**Pacific Gas and
Electric Company**
Power Generation
Fossil Plant Construction

Gateway Generating Station
3225 Wilbur Ave.
Antioch, CA 94509
(925) 459-7200

Subject: Gateway Generating Station (Docket 00-AFC-1C)
Petition for a Change to Gateway Generating Station Project Inlet Chiller System

Petition for a Change to the Gateway Generating Station Project Inlet Chiller System

Figure 2.1-1, page 1 of 4

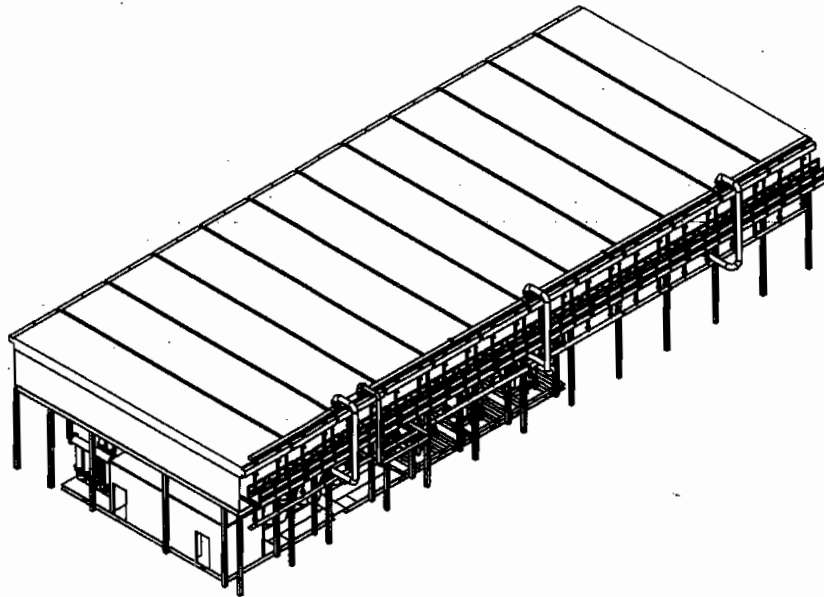
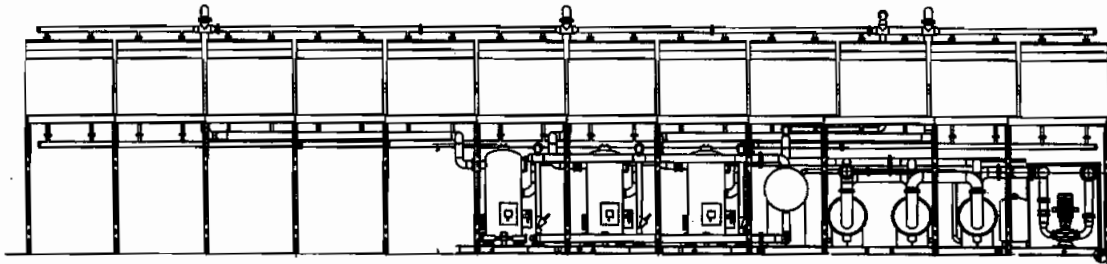
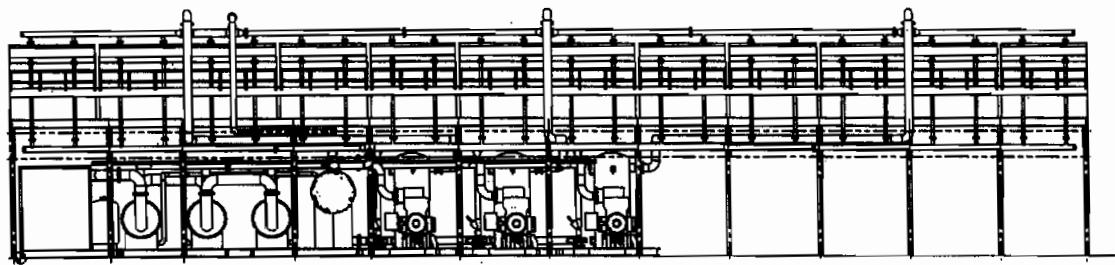
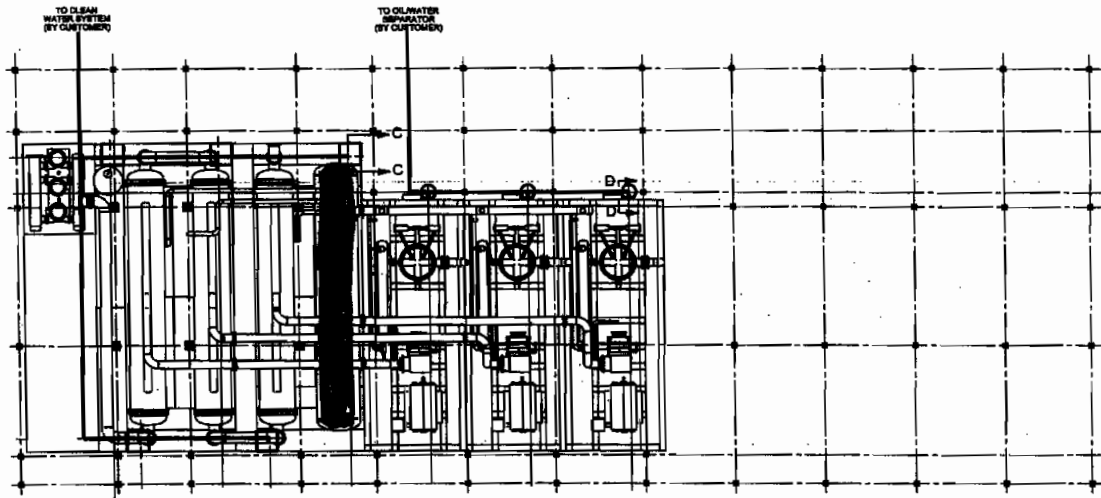
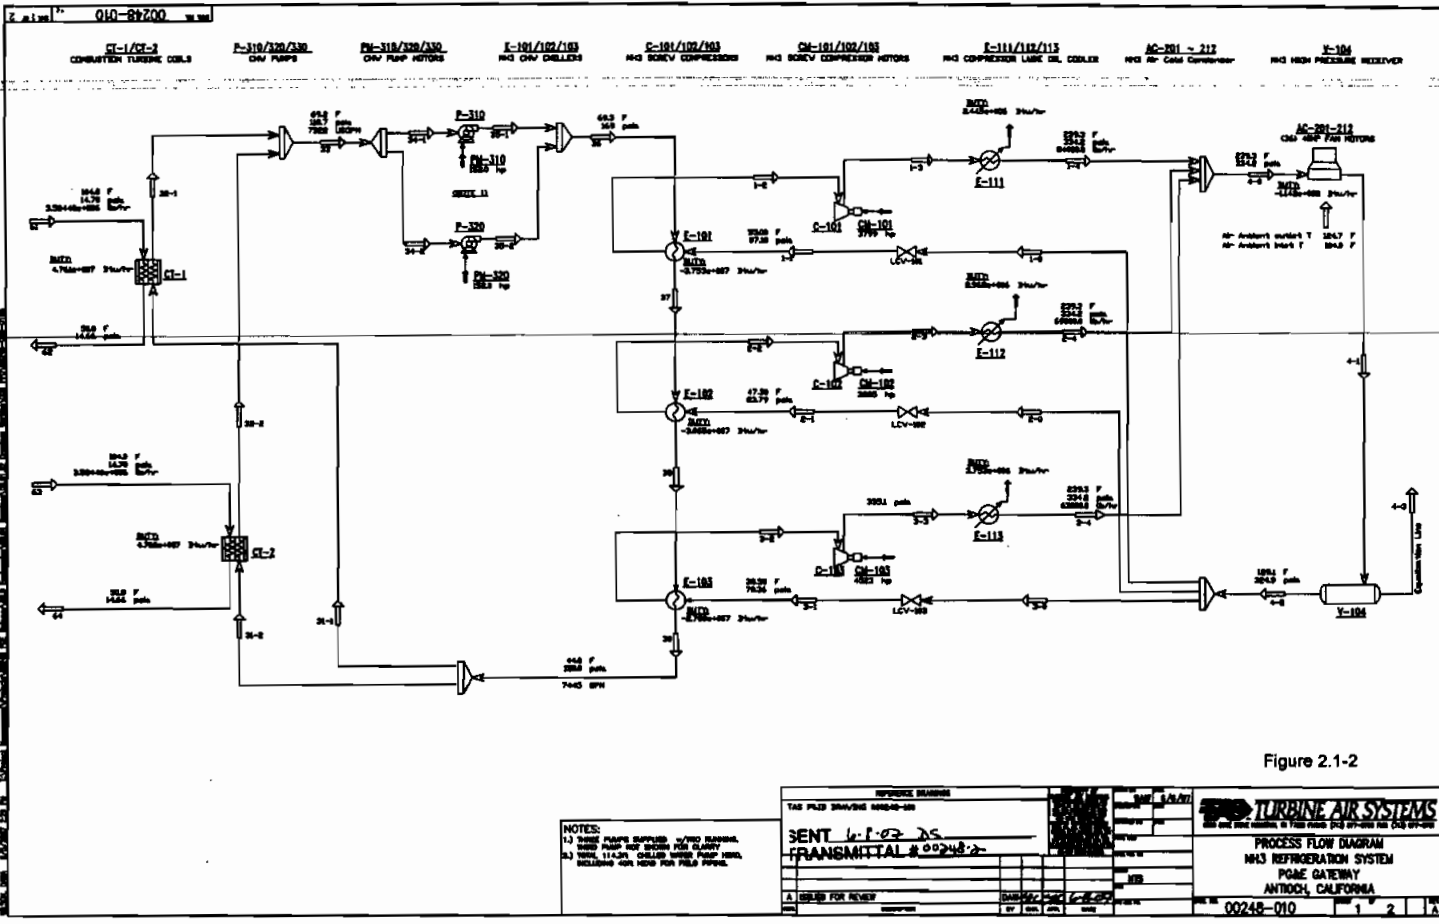
PG&E is proposing to change the refrigerant that will be used in the inlet chiller system from R134A to anhydrous ammonia. (The inlet chiller system was approved by the CEC on August 1, 2007, as part of PG&E's dry cooling amendment, to replace the original evaporative cooling system.) The electric chiller system is designed to reduce the inlet air temperature to the combustion turbine to 50 °F by drawing the inlet air across cooling coils containing anhydrous ammonia chilled water. A general layout arrangement for the chiller system is shown in Figure 2.1-1 and a process flow diagram is shown on Figure 2.2-2.

The proposed chiller system selected is an anhydrous ammonia-based mechanical chiller unit. The chiller system will comprise two subsystems, a chilled water system and a refrigerant system. The chilled water system is a closed-loop system where chilled water will be circulated through cooling loops in the combustion turbine's inlet air duct. After passing through the inlet air duct cooling loops, the water will be pumped to one of three shell and tube heat transfer vessels. The second system is the refrigerant loop, consisting of three screw compressors, ammonia condensers, a 7,100 gallon ammonia receiver vessel, three heat transfer vessels, and a lubricating oil system with a fin-fan cooler.

FIGURE 3.1-1
AMMONIA CONCENTRATIONS
CONSEQUENCE ANALYSIS
 PG&E GATEWAY GENERATING STATION
 ANTIOCH, CALIFORNIA

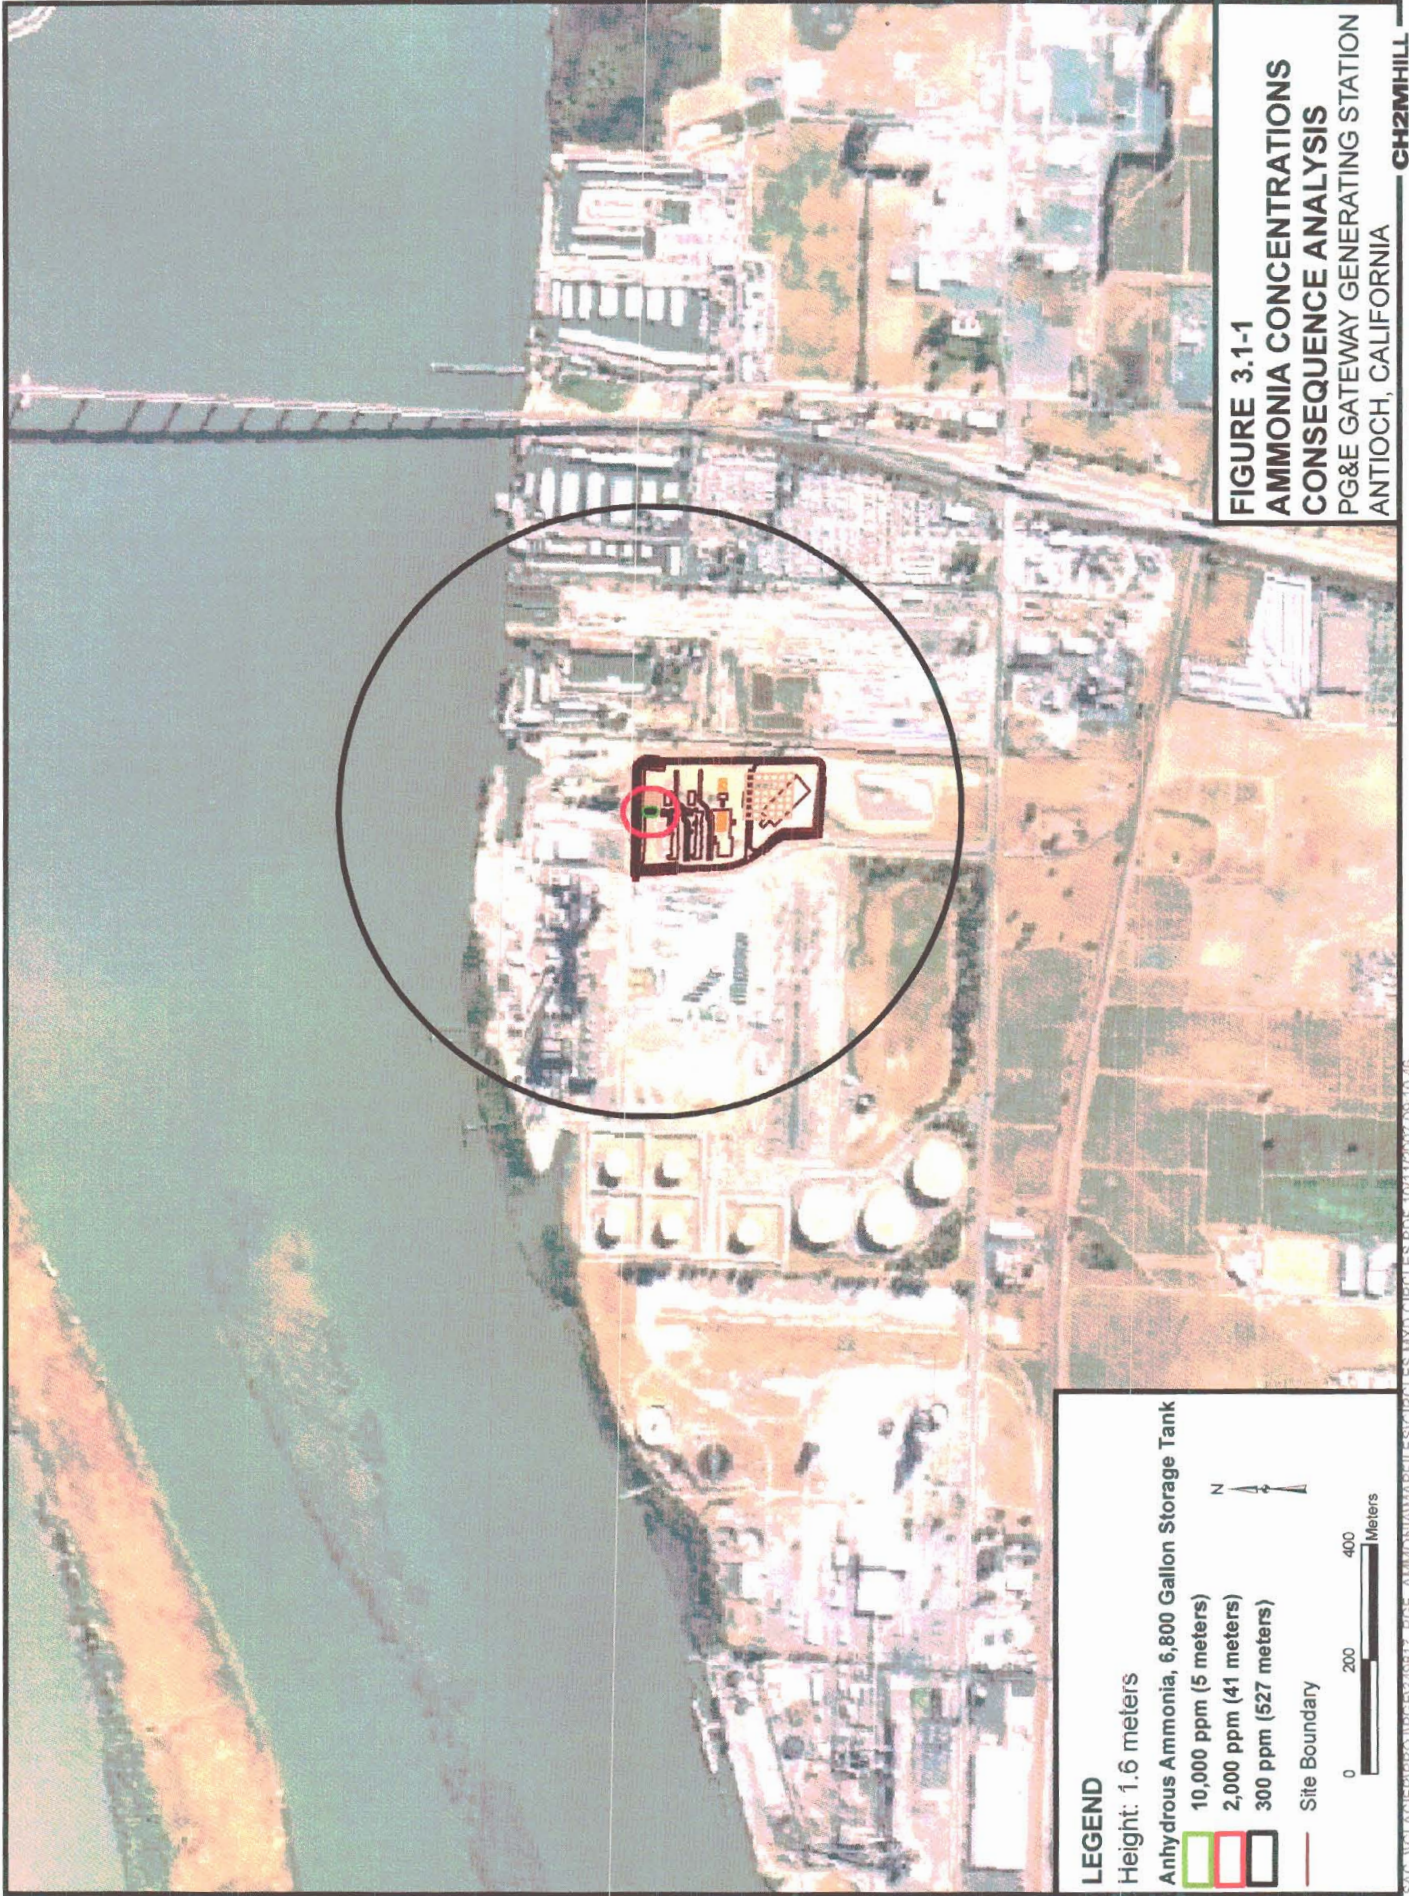
The results of the assessment indicate that the lethal concentrations (10,000 parts per million) of ammonia would occur within 16 feet of the ammonia receiver. This concentration represents a risk to PG&E workers and PG&E will incorporate training and engineering controls (monitoring, control, lock-out tag-out procedures, and alarms systems) to ensure workers are protected. The distance to the lowest concentration posing a risk of lethality, 2,000 parts per million, is 133 feet, based on 60 minutes of exposure. The 2,000 ppm isopleths extends off the GGS site to the north, approximately 52 feet onto the adjacent power plant's site. As the adjacent power plant also uses and stores ammonia, the risk to these workers is not considered as significant as compared to the impact on the general public. Figure 3.1-1 shows the extent to which the ammonia (both 10,000 and 2,000 parts per million) plumes impact offsite areas.
